## CITY PLANNING COMMISSION AGENDA

ITEM NOS: 5.A-5.E

**PROJECT:** THE RENAISSANCE AT INDIGO RANCH

1. **Project Description:** This project consists of five applications:
  - a. An amendment to the Stetson Ridge Master Plan which changes seven acres of commercial and 14 acres of residential at 12-24.99 dwelling units per acre (du/ac) to 21 acres of residential at 3.5-7.99 du/ac (**FIGURE 1**);
  - b. A rezoning of 10 acres zoned A/AO (Agricultural with Airport Overlay) to PBC/AO (Planned Business Center with Airport Overlay);
  - c. A concept plan showing five lots within the proposed 10 acres of commercial (**FIGURE 2**);
  - d. A rezoning of 21 acres from A/AO (Agricultural with Airport Overlay) to PUD/AO (Planned Unit Development, single family detached, 35-foot maximum height, maximum 4.78 du/ac with Airport Overlay) for a single-family residential development; and
  - e. A development plan for a 101-lot single family (small lot PUD) development covering 21 acres. (**FIGURE 3**).

**DEV'T PLAN** **FIGURE 3**

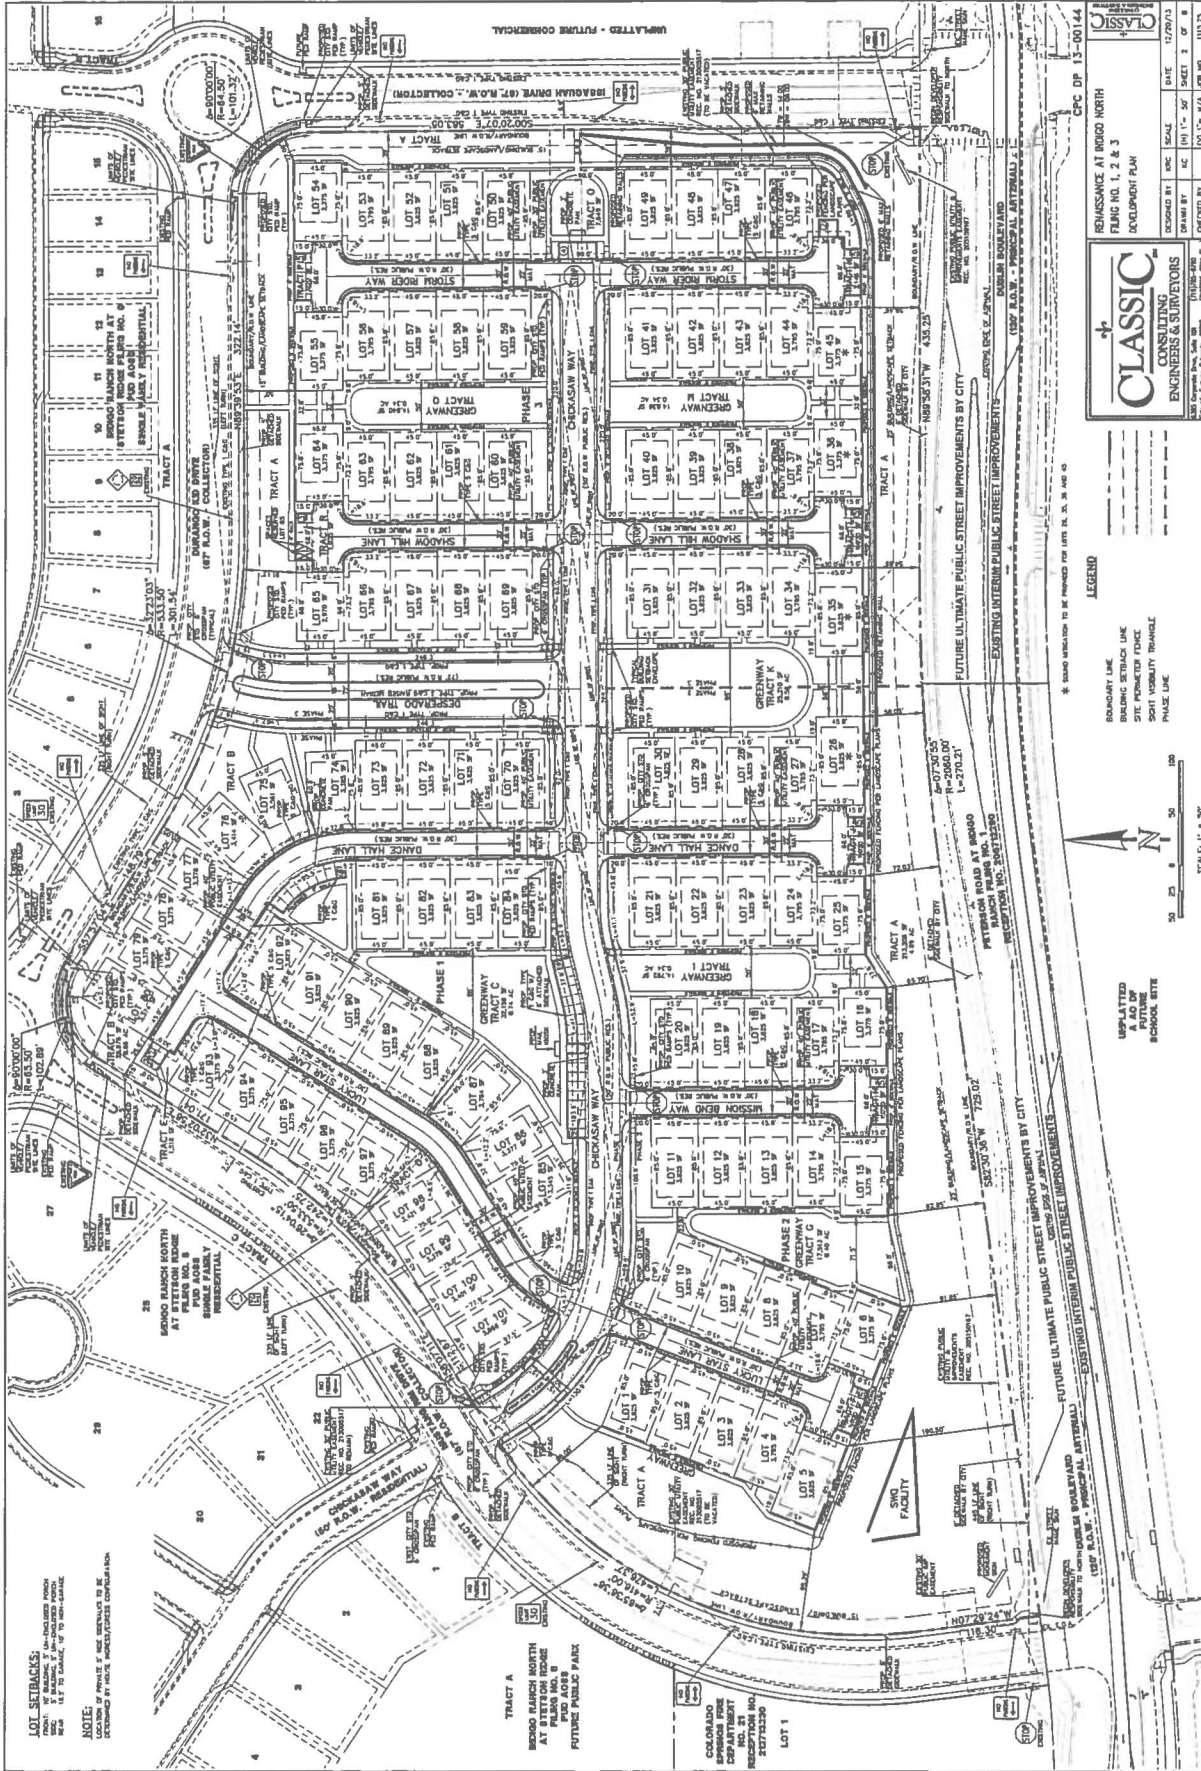
This application meets most of the review criteria and satisfies the intent of the small lot PUD concept. Two items that deviate from the criteria are road connections and the amount of units that are not Greenway Orientated units.

Within Chaparral Point, the internal rear access roadways are continuous and connect with a looped system. Within this proposal, many of the units are accessed with dead end streets (called "access" streets with a 22 foot mat/27 foot width to back of curb); however the number of units being served by the dead end streets is limited to not more than 10. The dead end streets do reduce the amount of pavement and provide adequate access to the units. City Engineering and Fire support this concept as public streets.

The second deviation is the number of units that do not actually front onto a greenway. The design manual limits the amount of non-greenway units to 10%; this proposal includes approximately 20% non-greenway units. While the non-greenway units do not have front loaded garages (all garages accessed in the rear), they do orient toward a street instead of a greenway. The minimum greenway width called out within the manual is a 40-foot width. Many of the units that do not face the greenway are along the two adjoining collector streets, Mustang Rim and Issaquah Drive.

Noise issues are one of the review criteria that deserve discussion. The typical standard to address noise is the construction of a noise wall and additional setbacks. While the setback area for this development is significant adjacent to Dublin, the applicants are not installing a noise wall and the grade actually rises from the road to the finished units. Instead, the applicants had a noise study completed to address this issue. Apparently the results indicate that additional soundproofing is necessary for those dwellings adjacent to Dublin. Staff has requested a copy of the study and a proposed technical modification below is suggested to update the development plan to address the necessary noise mitigation.

1. Sound study information from LSC was not provided. The development plan needs to include information as to specific units that are subject to additional sound attenuation. Provide a copy of the study and indicate on the development plan the affected units and the necessary noise mitigation.
  2. Provide a detail of the retaining walls (materials).
  3. Address the items noted by the Landscape Architect consisting of the following:
    - a. Include all street names and classifications on the landscape plan.
    - b. Show all Landscape categories requirements (setbacks, internal, and buffers if there are commercial uses across the non-arterial).
  4. Provide a letter from the Metro District which indicates that they will accept all responsibility for the ownership and maintenance of properties as noted on the plan.
-

**Approve** the Renaissance at Indigo Ranch Development Plan, based upon the finding that the development plan complies with the development plan review criteria in City Code Section 7.5.502.E and with the PUD development plan review criteria in City Code Section 7.3.606, subject to compliance with the following technical and/or informational plan modifications:

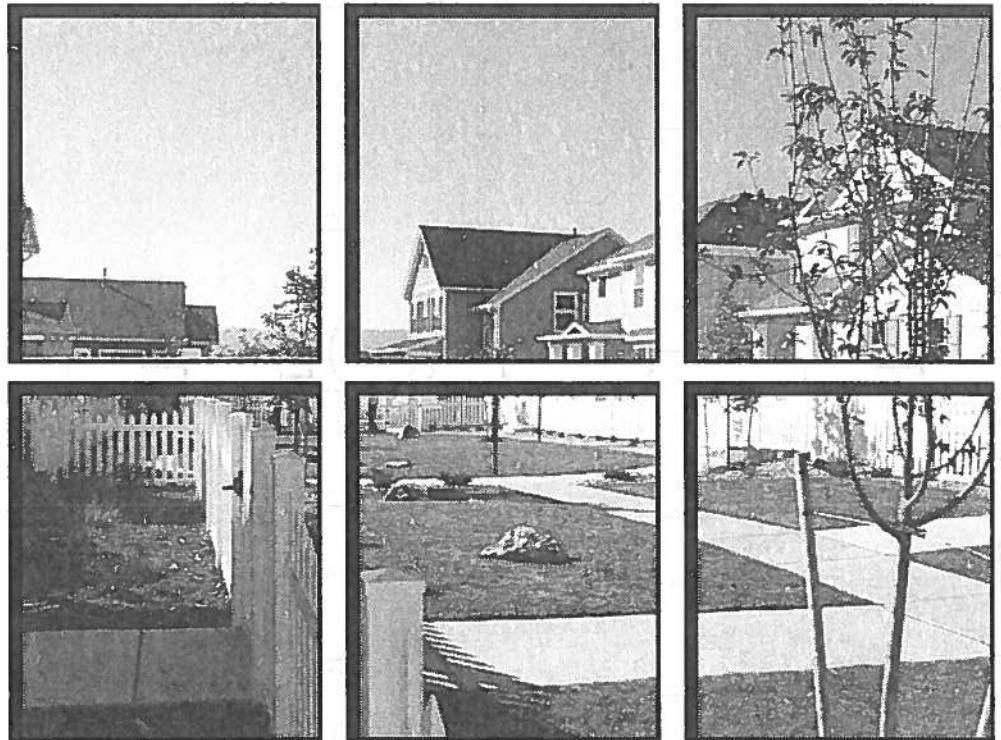
Capacities of the schools that will serve this proposed development have surpassed their design limit. Accelerated residential growth and strong growth potential heighten the School District's concern regarding its ability to provide adequate educational opportunities.

Based upon our calculations, land dedication is not feasible from a development of this size. District 49 cautiously approves the Zoning Change, with the clear understanding of the infrastructure capacity being inadequate and requests that the developer agree to pay cash in lieu of land at the current market value of land within the District. The District would like the opportunity to respond to any land use changes associated with this project.

**FIGURE 7**

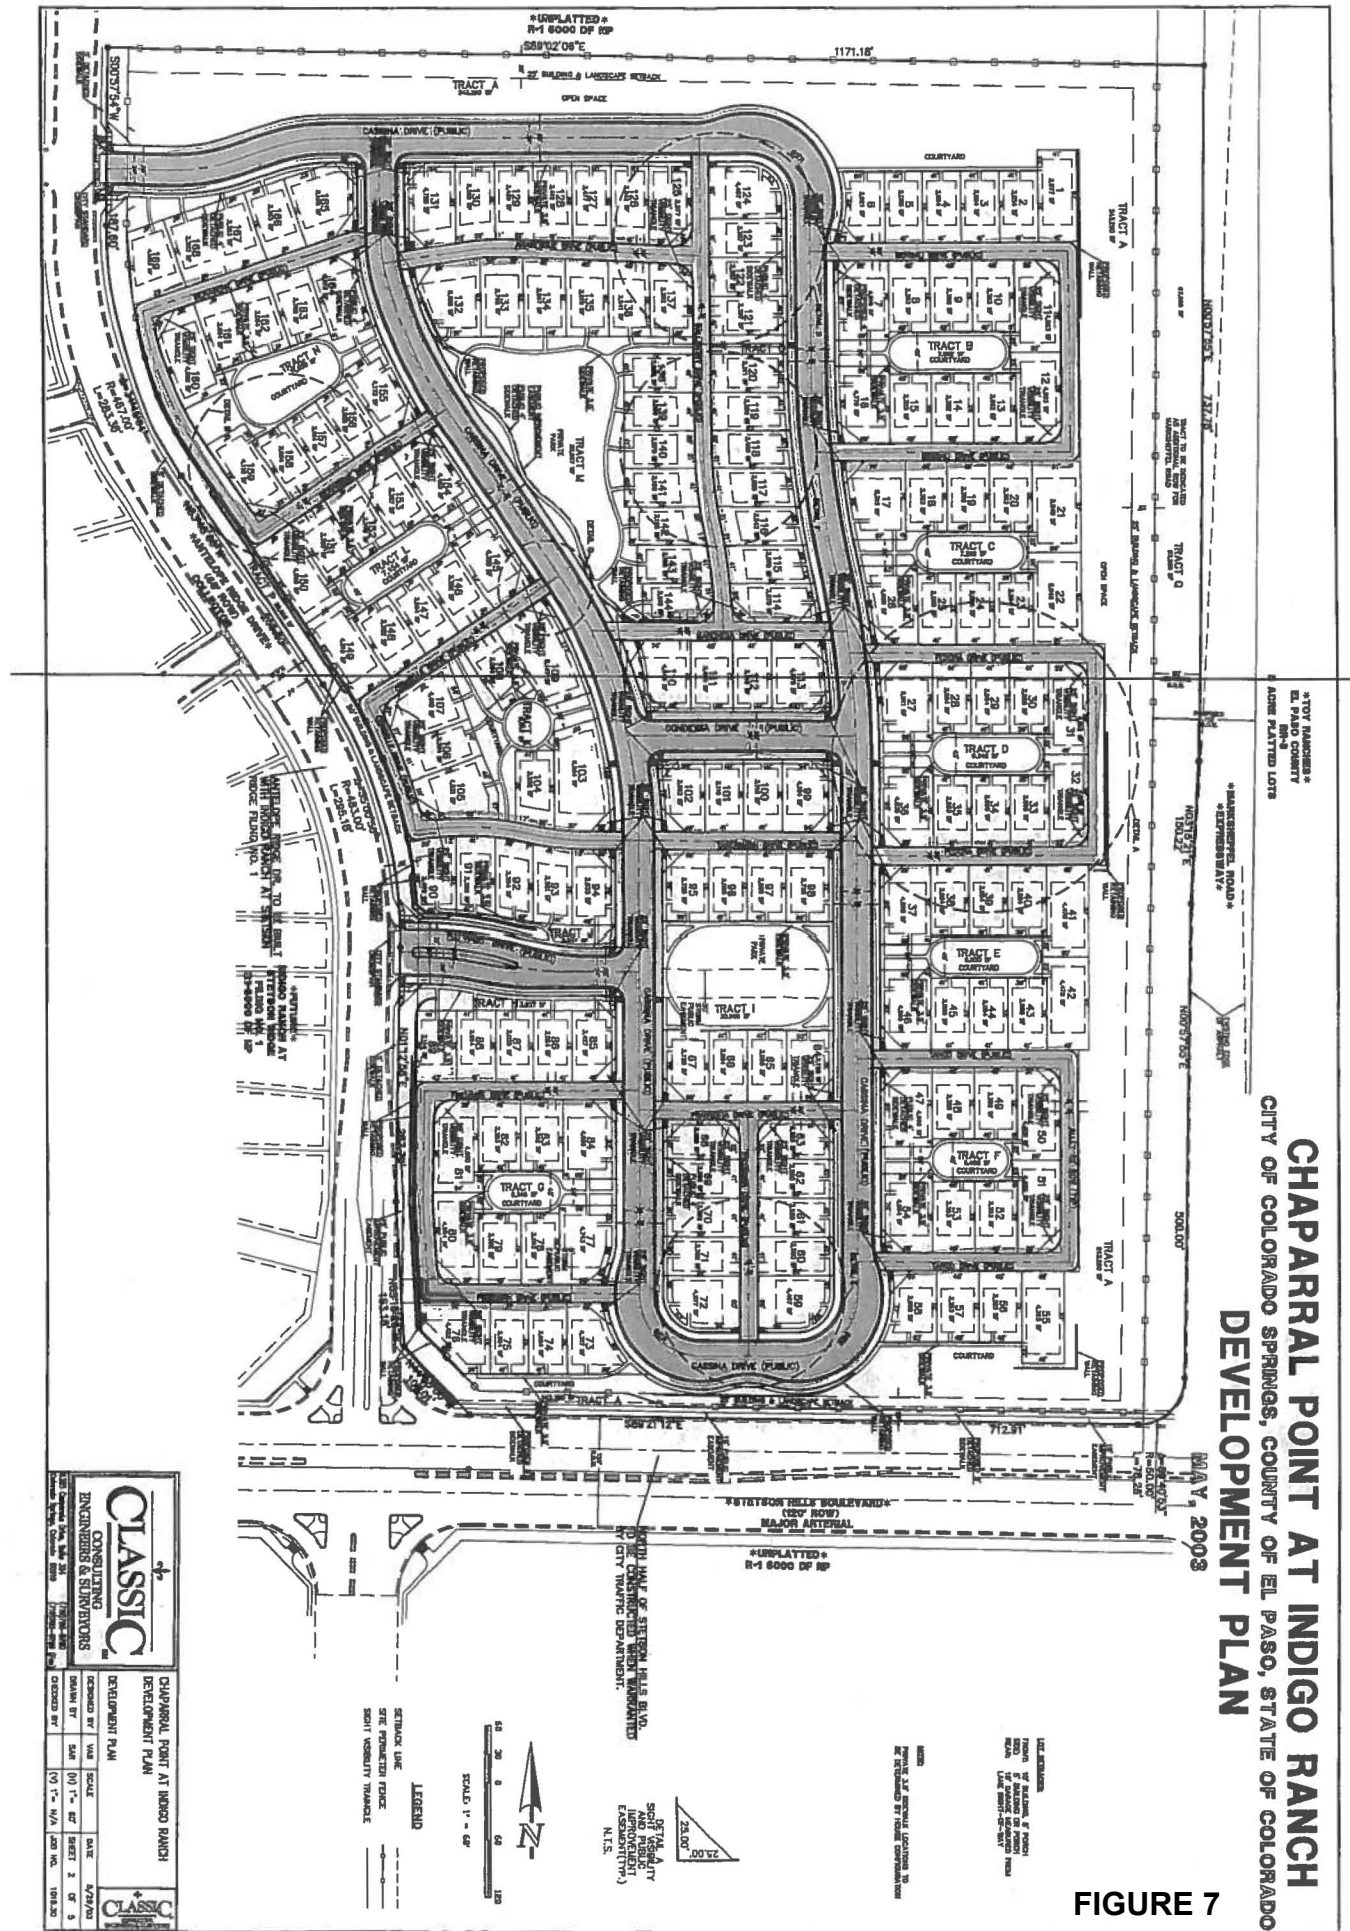
There have been a handful of small lot PUDs with varying degrees of success. One of the more successful small lot subdivisions that follows many of the Small Lot PUD Guidelines (though the guidelines were not adopted until 2005) is the Chaparral Point at Indigo Ranch, approved in March of 2004. Chaparral Point is located along the west side of Marksheffel and north of Stetson Hills Boulevard, approximately one mile south of this application. The proposed project will closely replicate that development (**FIGURE 7**).
